Re: City of Stockton's Comments on Draft BDCP and Associated Draft EIR/EIS

The City of Stockton (City) appreciates the opportunity to comment on the Draft Bay Delta Conservation Plan (BDCP or Plan) and associated Draft Environmental Impact Report/ Environmental Impact Statement (DEIR/EIS).

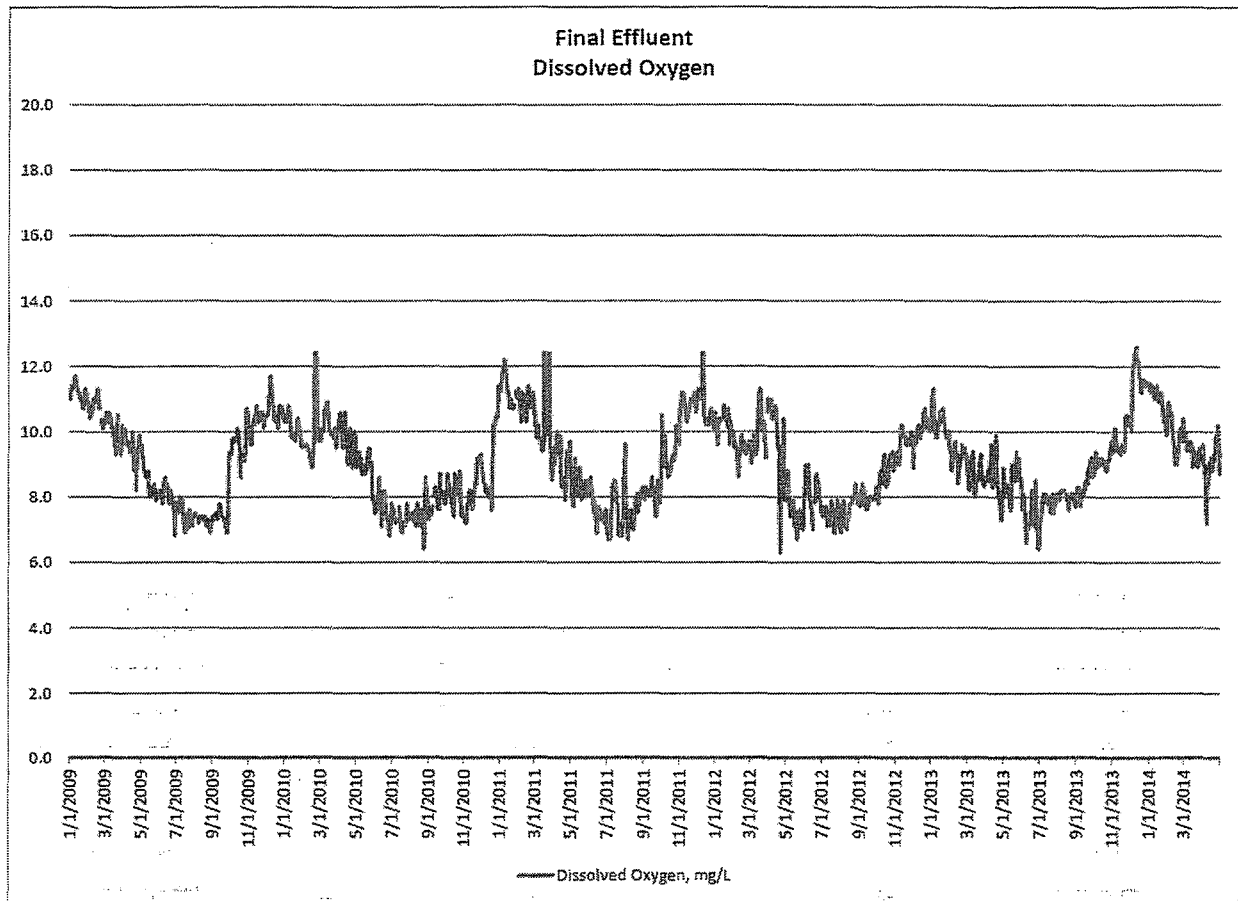
Since 2007, the City's tertiary treatment system at its Regional Wastewater Control Facility (RWCF) has been providing ammonia removal. The treated wastewater routinely provides wastewater with daily minimum DO values greater than the 5 mg/L and 6 mg/L DO water quality objectives (Figure 1) and carbonaceous biochemical oxygen demand (CBOD) in the non-detectable range (Figure 2).

Attributing low DO content in the Ship Channel to the City's discharge is not accurate or based on current evidence. Algae and their byproducts are responsible for most of the oxygen demand in the Ship Channel. (Foe, et al., 2002, p. 18.) Further analyses also found a strong correlation between increased concentrations of chlorophyll-a upstream at Mossdale and decreased DO concentrations in the Ship Channel upstream. (Foe, et al., 2002, p. 20.) The responsibility for current algae concentrations appears to rest with increased use of fertilizers and agricultural and wetland activities in the watershed. (Central Valley Regional Board Final Staff Report, 2005.) The DEIR/EIS should be updated throughout to reflect upgrades at the City's RWCF, upgrades at the Ship Channel by the Port of Stockton (added aeration), and should be inclusive of other stressors as indicated by the Central Valley Regional Board.

Figure 3. GHG Distribution per Treatment level.

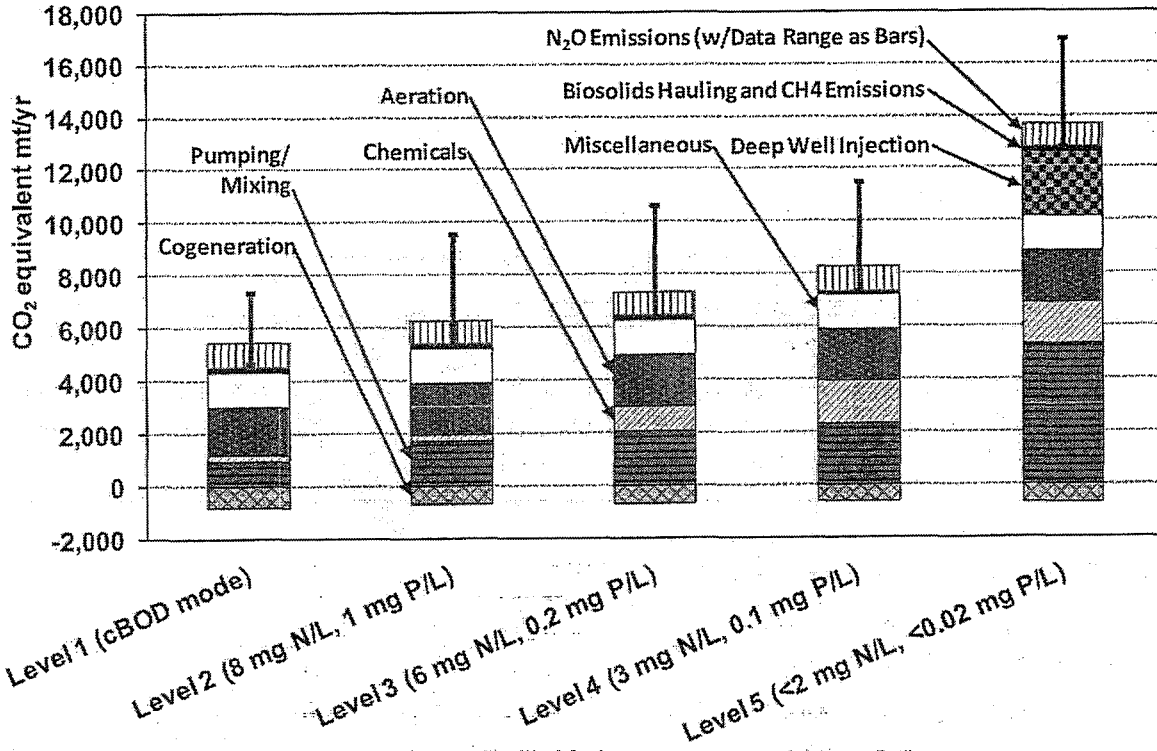
The Water Environment Research Foundation Sustainability Report (Falk, et al., 2011) (WERF Report) investigated at what point the sustainability impacts of increased levels of nutrient removal outweigh the benefits of improved water quality. Within the report, GHG emissions were measured along with potential algal production as a water quality surrogate. The distribution of GHG emissions for pumping/mixing, aeration, cogeneration, N₂O emissions, chemical manufacturing/delivery/use, deep well injection (Level 5), and sum of CH₄ emission and biosolids is provided in Figure 3 below.

The three largest contributors to GHG emissions are all energy related: aeration, pumping/mixing, and deep well injection (Level 5). The steady increase in emissions from Levels 2 to 4 is due to chemical demand for methanol to fuel denitrification, alum, and polymer. More chemicals are required for tertiary add-on solids separation processes with more advanced treatment. For example, the use of high rate clarification (assume dose of 50 mg/L alum; 2 mg/L polymer) increases chemical demand from Level 3 to Level 4 or 5. The least significant variables were methane and biosolids hauling. Besides GHG emissions, the impact on the receiving water body using the water quality surrogate is potential algal production. The algae production results in Figure 4 are on the primary y-axis (left-hand side) along with the GHG emission equivalents on the secondary y-axis (right-hand side). The algal savings are 95 percent from the Level 1 to 3. Both Levels 4 and 5 remove an additional 4 percent (99 percent total removal with respect to Level 1) with a corresponding doubling of GHG emissions from Level 3 to 5.

Figure 4. GHG Emissions and Algae Production per Treatment Level.

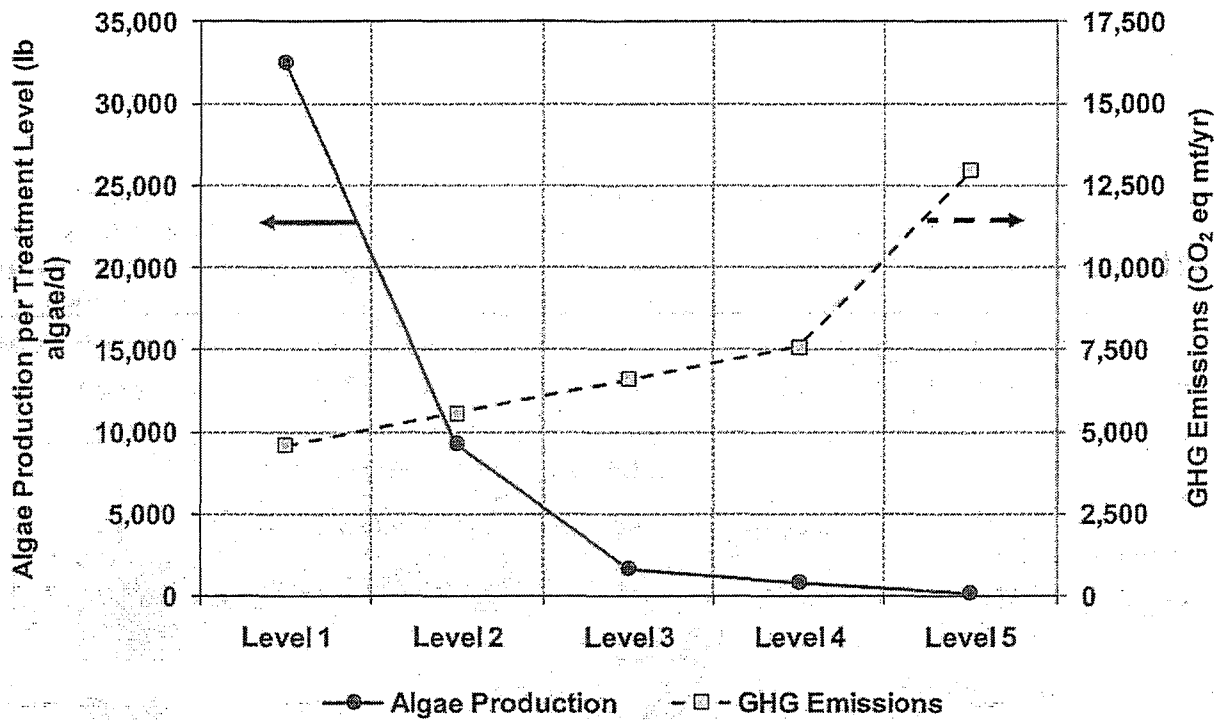
The overall message from the WERF Report is that a combination of Level 3 treatment and best management practices on non-point sources might be a more sustainable approach than solely regulating point source discharges for achieving comparable water qualities. The BDCP DEIR/EIS must assess all impacts to GHG emissions including excessive treatment levels for water and wastewater treatment plants along the Delta that could result from the BDCP's focus on "other stressors." If, as a result of the BDCP, the City were required to increase its treatment requirements, all anticipated treatment requirements, such as reverse osmosis, cooling and up to and including Level 5 treatment levels, the increased cost and environmental impacts associated with increased treatment, including mitigation for GHG emissions, must be fully mitigated by the BDCP.
